# UNITED STATES PATENT AND TRADEMARK OFFICE

APPLICATION NO.	FILING DATE	FIRST NAMED INVENTOR	ATTORNEY DOCKET NO.	CONFIRMATION NO.
10/734,261	12/15/2003	Mitsugu Sato	H6808.0005/P005-A	1481
24998	7590	12/26/2007	EXAMINER	
DICKSTEIN SHAPIRO LLP			JOHNSTON, PHILLIP A	
1825 EYE STREET NW			ART UNIT	PAPER NUMBER
Washington, DC 20006-5403			2881	
MAIL DATE		DELIVERY MODE		
12/26/2007		PAPER

<b>Office Action Summary</b>	Application No.	Applicant(s)
	10/734,261	SATO ET AL.
	Examiner Phillip A. Johnston	Art Unit 2881

***Detailed Action***

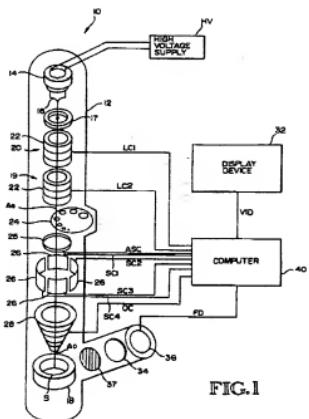
5. Regarding claim 24, Keese discloses a charged particle beam apparatus comprising: a charged particle source; an optical element for adjusting a charged particle beam emitted by the charged particle source; an alignment deflector for aligning the axis of the charged particle beam with respect to the optical element; and a control device for calculating a two dimensional deviation between images when the optical element is varied, See Col. 4, line 23-44, where Keese teaches scanning electron microscope 10 having electron gun 14 (the particle source), condenser lenses 19 and

20 (note Figure 1 below) alignment coils 22 (deflectors), astigmatism coil 25, and objective lens 28 (optical element), which focuses the beam onto specimen S.

Keese also teaches controlling microscope 10 with computer 40 (control device), which automatically varies the focus of objective lens 28 between extremes of the focal range (a variation of an operation condition), then image processing circuit 46 detects and generates image translation signals IND (a two-dimensional deviation between images) from which the amount of beam alignment correction is calculated with control circuit 50, and supplied to the alignment coils as signals LC1 and LC2 (a parameter of each alignment coil) for adjusting electron beam alignment. Col. 5, line 38-62.
